Project **IEEE 802.16 Broadband Wireless Access Working Group** <<http://ieee802.org/16>>

Title **Clarify the EAP based Authentication Procedure**

Re: Contribution on comments to P802.16g-D1

Abstract In this contribution, we clarify the EAP based authentication procedure in Figure 477

Figure 477 --- EAP based Authentication Procedure

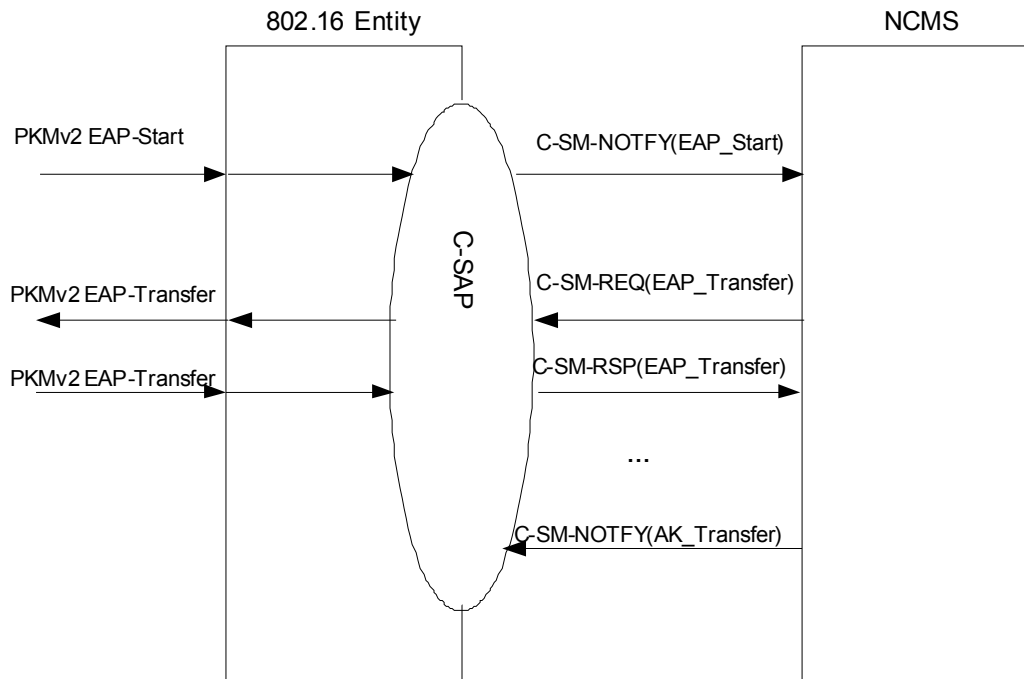
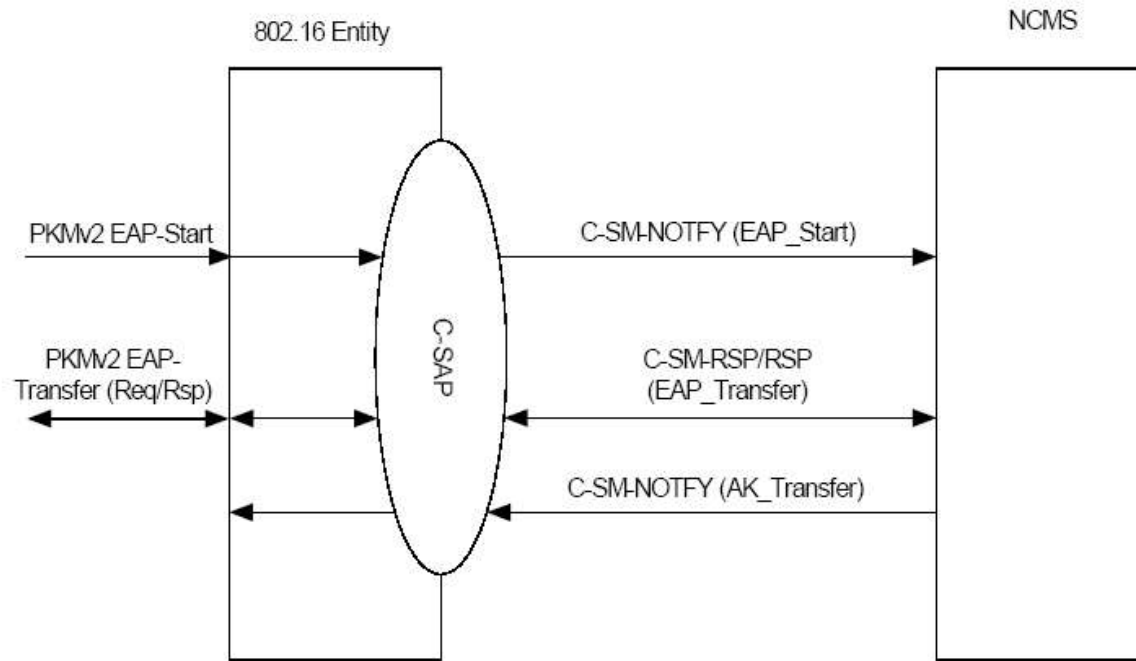
In Section 14.2.5.1 (EAP based authentication procedures), Figure 477, it is confused to use bi-direction arrow line to show interaction between 802.16 Entity and NCMS. It is hard to tell sequence of the call flow. Based on EAP specification, the C_SM_REQ is sent from NCMS to 802.16 Entity. The 802.16 Entity will send C_SM_RSP in response to it. It is better to separate them, which will make the flow more accurate.

This contribution clarifies the primitive diagrams by separating the C_SM_REQ/RSP primitive into two unidirectional arrow line.

[Modify section 14.2.5.1, replace Figure 477 with the following figures]
